REMINGTON ROAD

FLAT LAYOUTS CHANGES PROPOSAL REPORT

DELTA ARCHITECTS

REVISION: P1

FLAT FT08 Duplex – BLOCK C

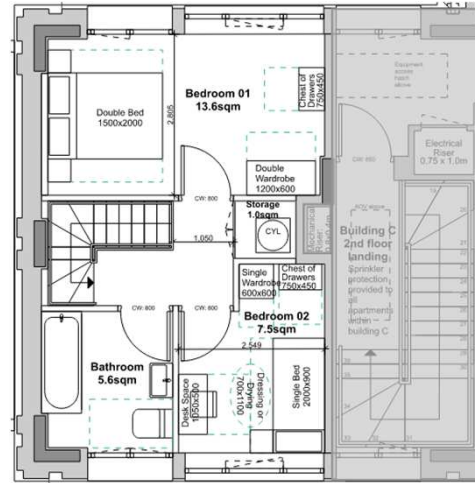
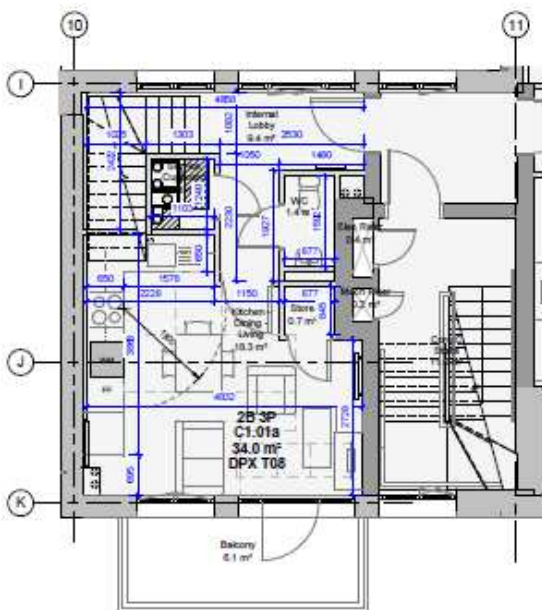
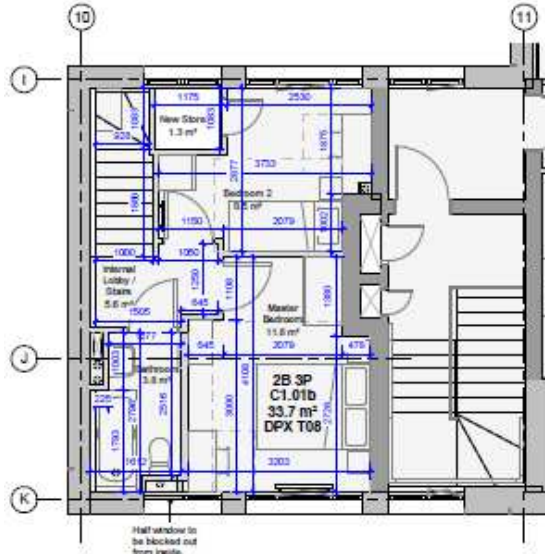
- Flat layout generally changed due to stairs pitch to comply with Part K.
- Utility cupboard moved downstairs for M&E maintenance purpose.
- Balcony moved to the left due to privacy – moved away from window in stair core C.
- Kitchen connected with living space to improve layout.
- Drainage strategy resolved, SVP's and stacks added.

- Flat layout generally changed due to stairs pitch to comply with Part K.
- Drainage strategy resolved, SVP's and stacks added.

FLAT FT09 – BLOCK C

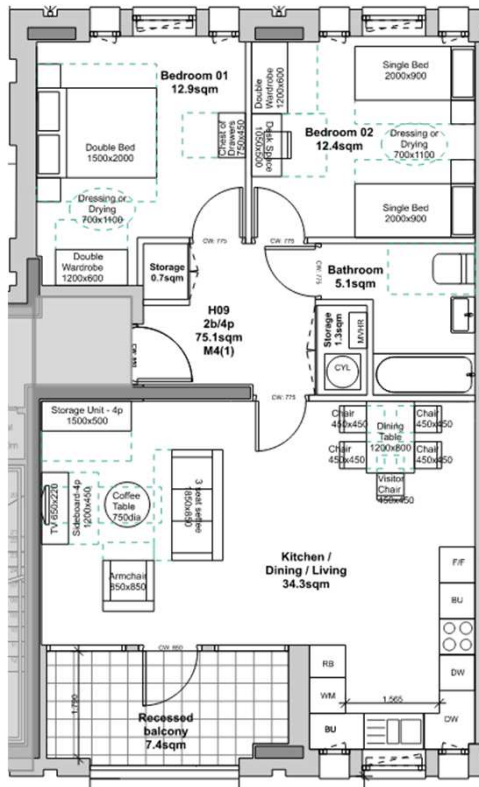
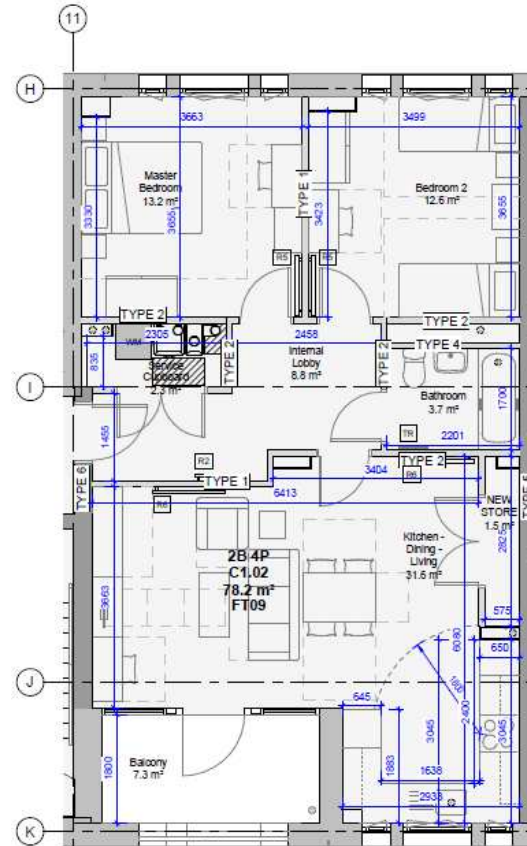
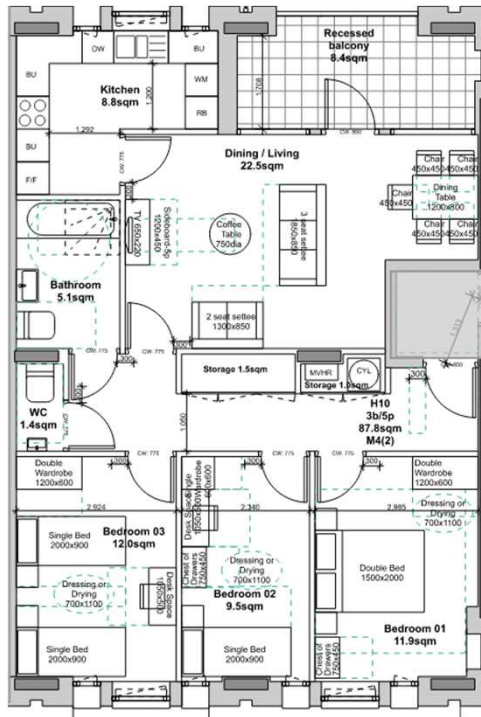
- Utility cupboard and storage re-arranged to improve minimum space required for M&E services.
- Two single bed changed to double bed.
- Bathroom layout standardised.
- Drainage strategy resolved, SVP's and stacks added.

FLAT FT10 – BLOCK A

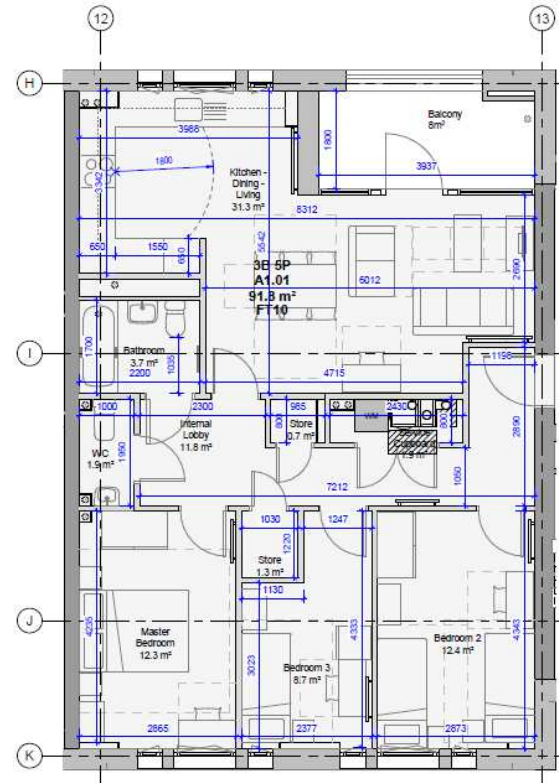
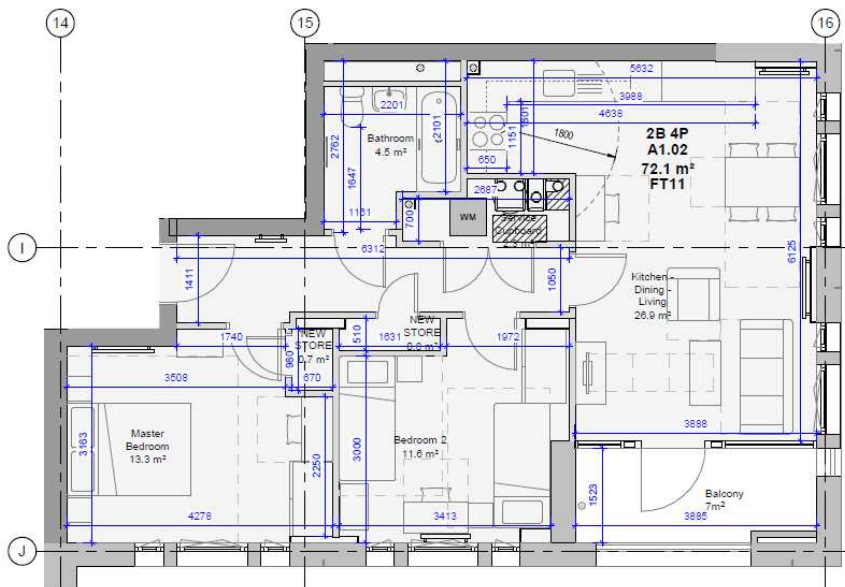
- Utility cupboard and storage re-arranged to improve minimum space required for M&E services.
- Two single bed changed to double bed .
- Kitchens and Living Spaces connected (open plan) to improve layout.
- Bathroom layout standardised.
- Drainage strategy resolved, SVP's and stacks added.
- Bedrooms enlarged with removal of lobby.

FLAT FT12 – BLOCK A

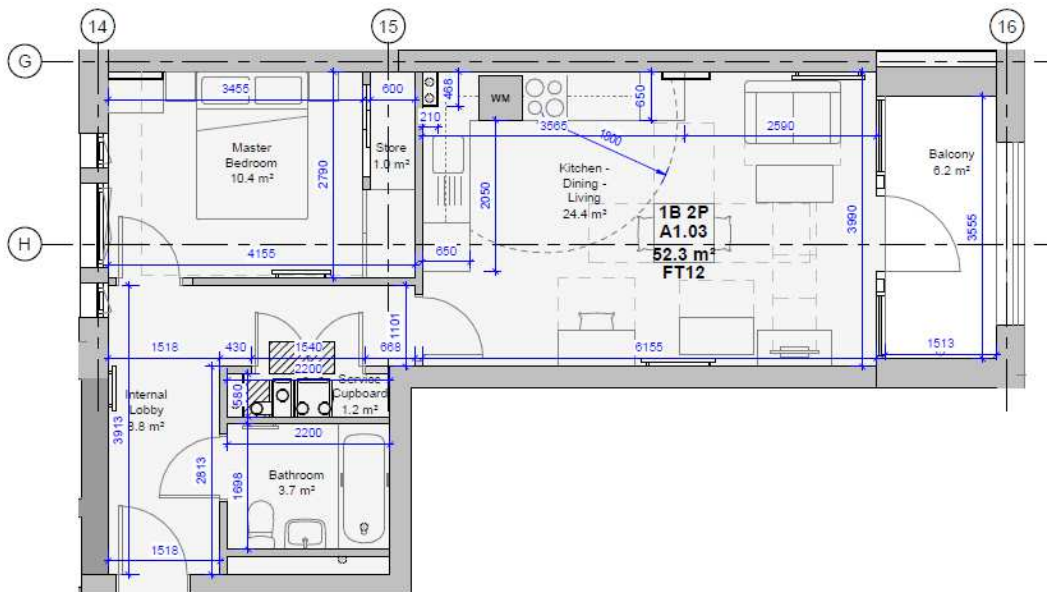
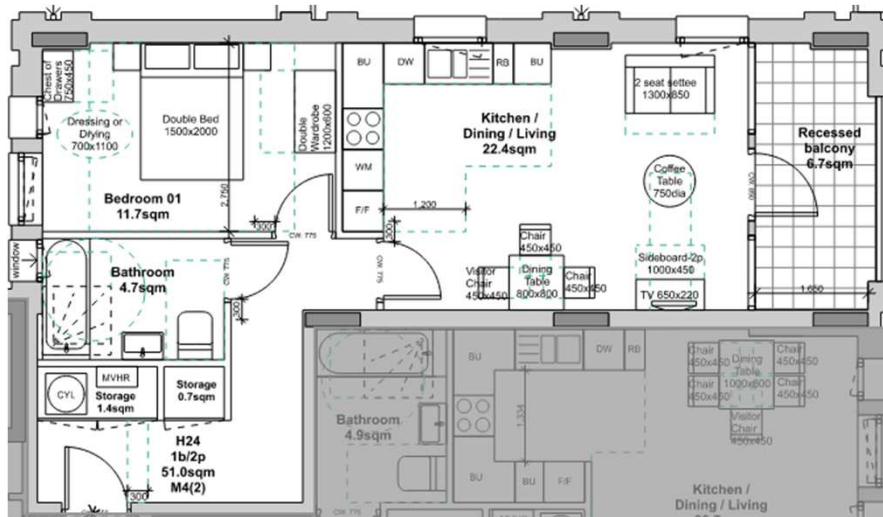
- Utility cupboard, storage and bathroom re-arranged to improve minimum space required for M&E services and M&E services in bathroom.
- Drainage strategy resolved, SVP's and stacks added.

FLAT FT12A – BLOCK A

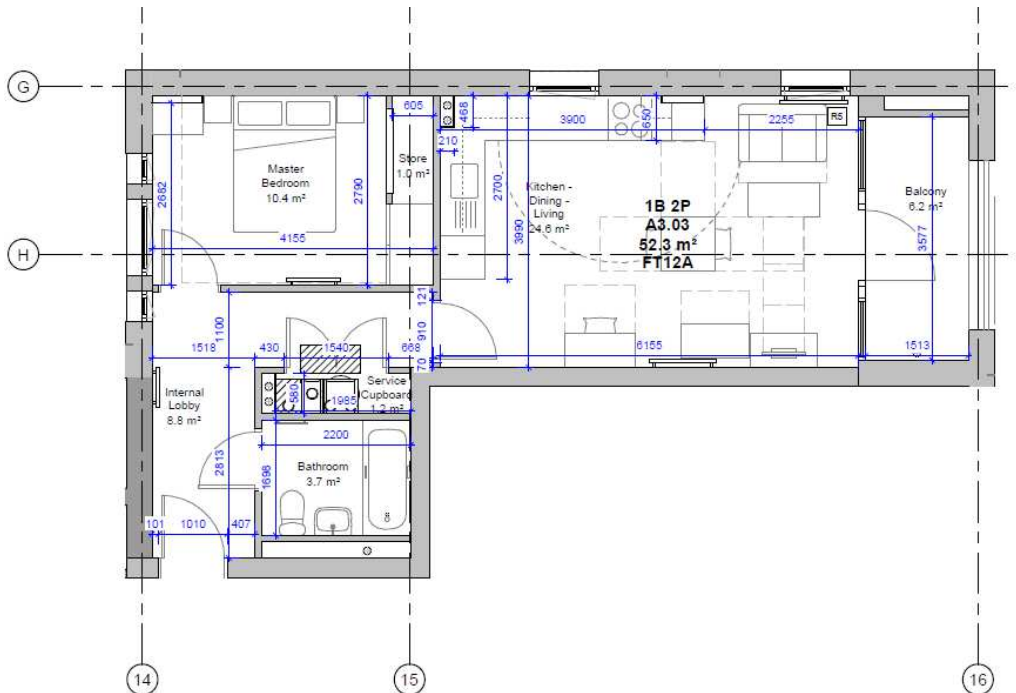
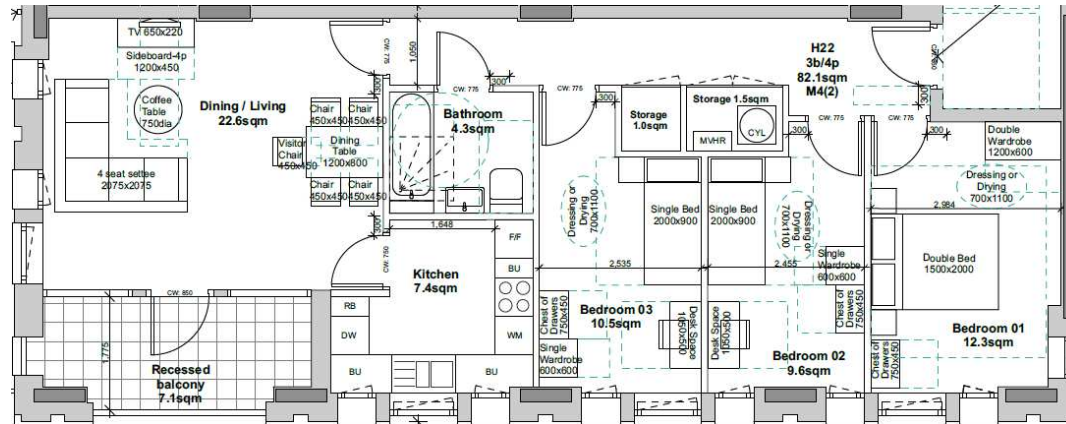
- Utility cupboard, storage and bathroom re-arranged to improve minimum space required for M&E services and M&E services in bathroom.
- Kitchen units extended to improve the cubic capacity.
- Drainage strategy resolved, SVP's and stacks added.

FLAT FT13 – BLOCK A

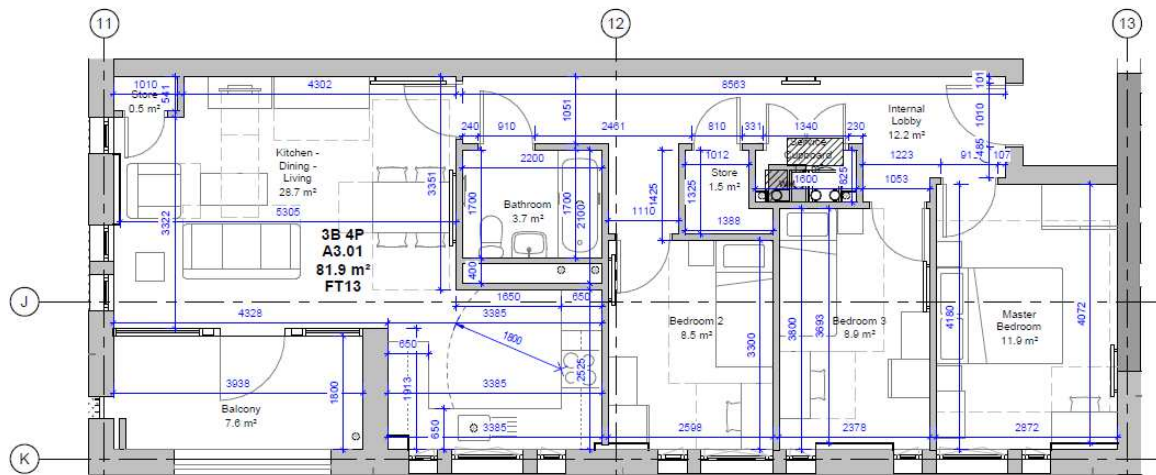
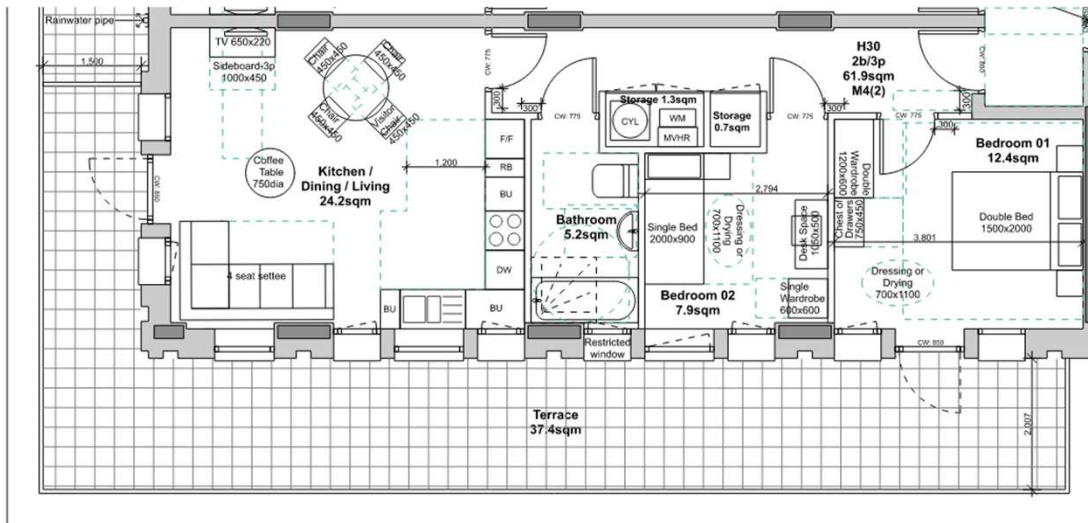
- Utility cupboard and storage re-arranged to improve minimum space required for M&E services.
- Kitchens and Living Spaces connected (open plan) to improve layout.
- Bay windows removed due to constructability. Windows made to brick dims sizes.
- Drainage strategy resolved, SVP's and stacks added.

FLAT FT14 – BLOCK A

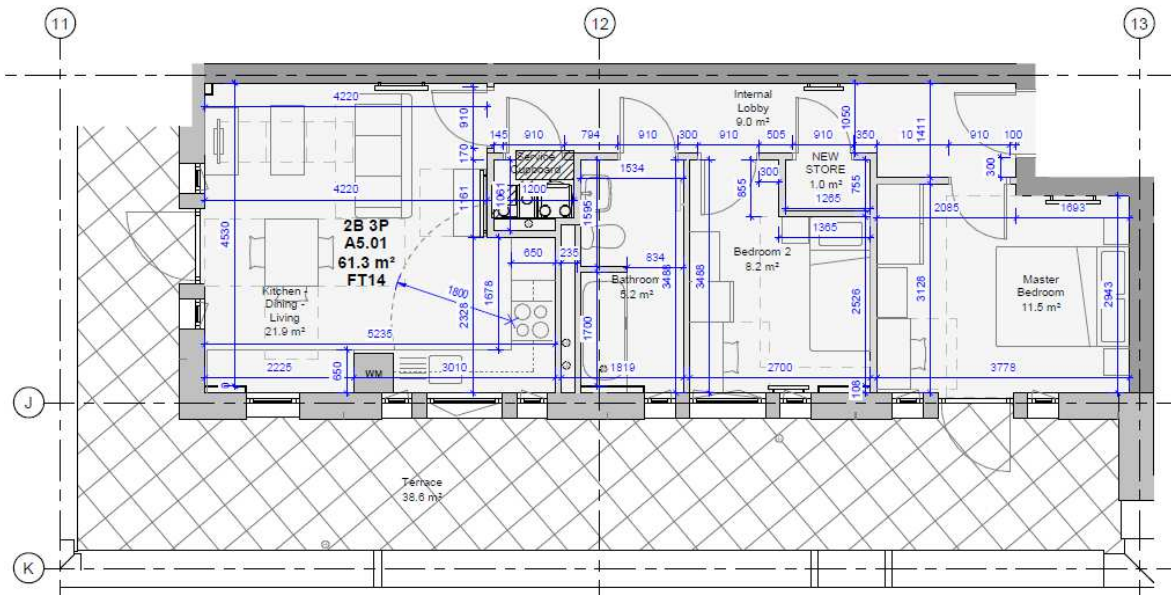
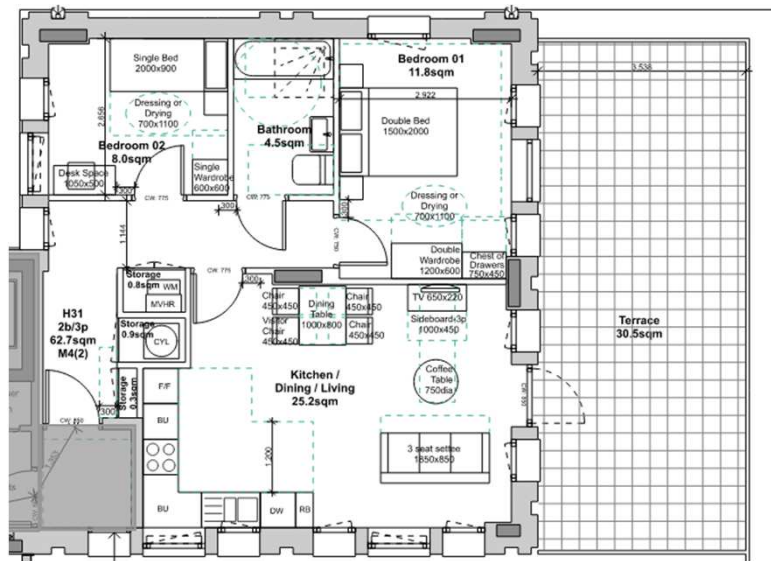
- Utility cupboard, storage and bathroom re-arranged to improve minimum space required for M&E services and bathroom.
- Bathroom layout changed, not enough space for bath services.
- Drainage strategy resolved, SVP's and stacks added.

FLAT FT15 – BLOCK A

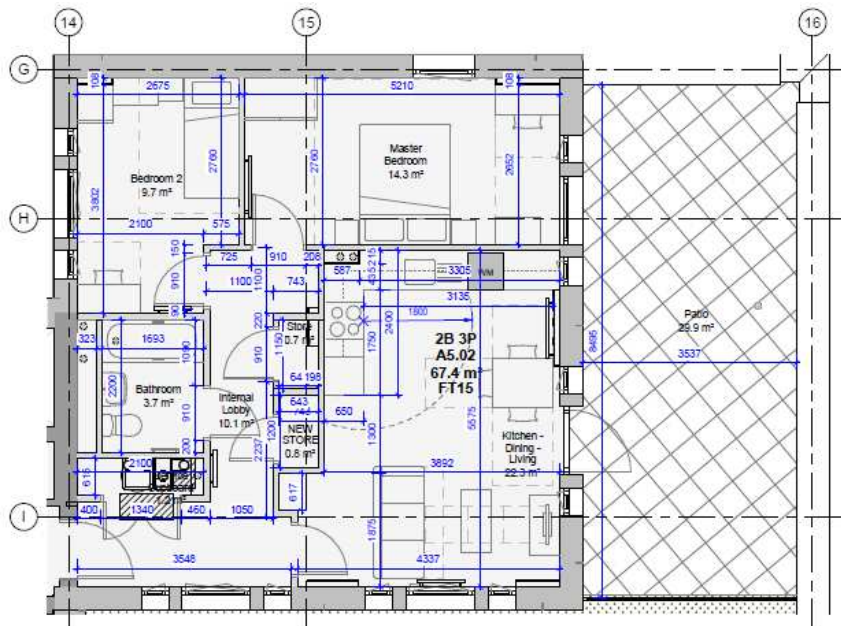
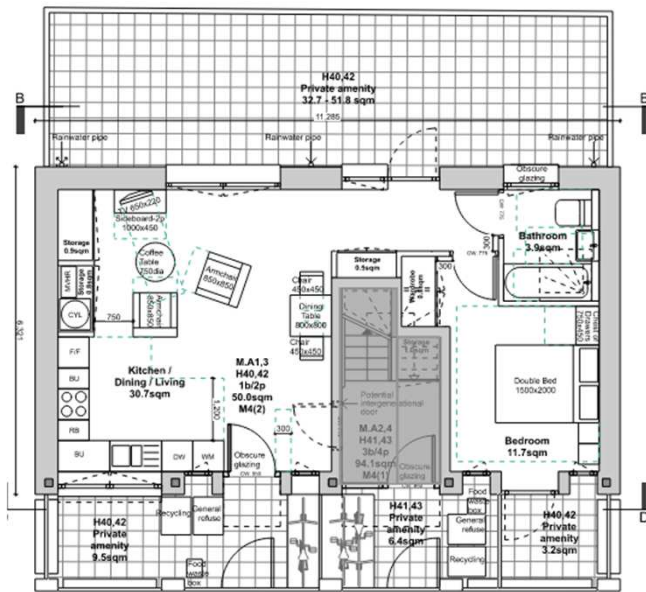
- Layout generally changed to accommodate utility cupboard storage for M&E appliances.
- The overall area of unit improved. The occupancy remains the same.
- Lobby removed from Communal Corridor to improve the flat layout.
- Bathroom moved centrally to improve layout and M&E services.
- Bedrooms enlarged with removal of lobby.
- Drainage strategy resolved, SVP's and stacks added.

MAISONETTE MT01 EAST

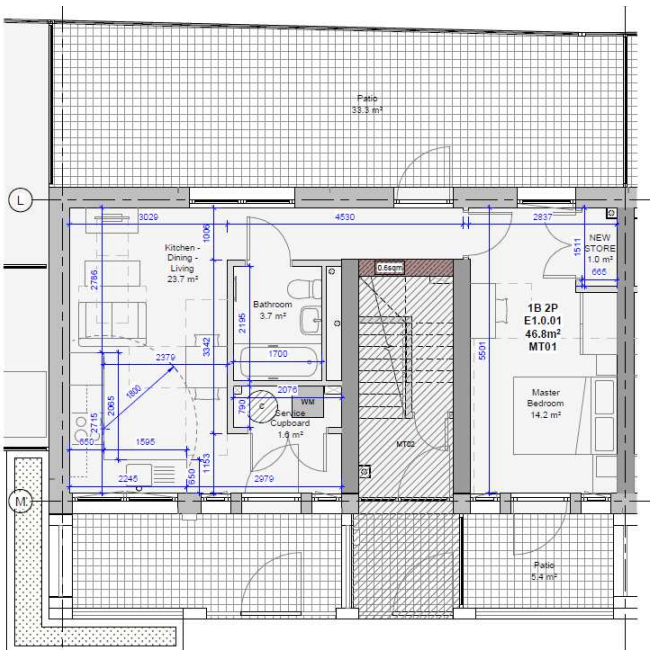
- Layout generally changed due to the main stair for MT02 in Ground Floor.
- Stairwell wall thickness increased, FR60 required. Planning stairwell did not work structurally, core walls did not meet fire requirements.
- Storage moved to accommodate M&E services space required.
- Bathrooms moved away from facades to allow more natural light and ventilation in the flat.
- Drainage strategy resolved, SVP's and stacks added.

MAISONETTE MT02 EAST

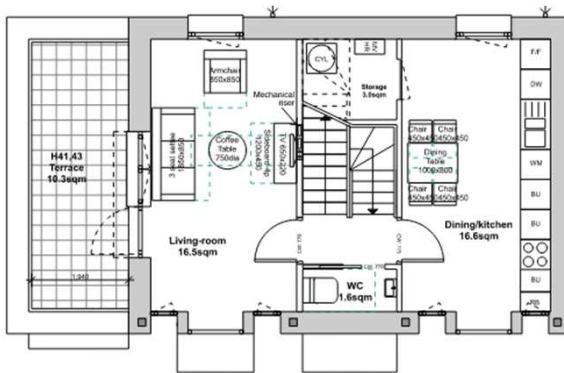
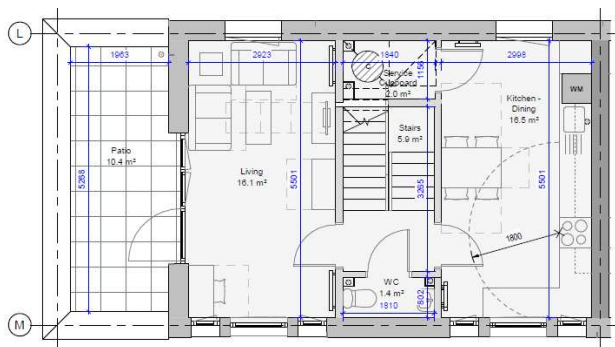
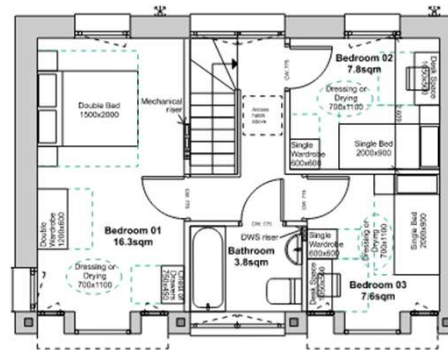
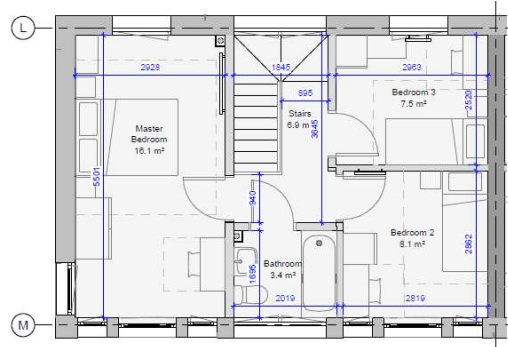
- Utility cupboard changed due to the main stair for MT02 to comply with Part K & M.
- Drainage strategy resolved, SVP's and stacks added.
- Bike to be store in the communal bike store due to privacy screen moved and reduced the front patio area.

- Single bedrooms layouts changed due to the main stair changes.
- Drainage strategy resolved, SVP's and stacks added.
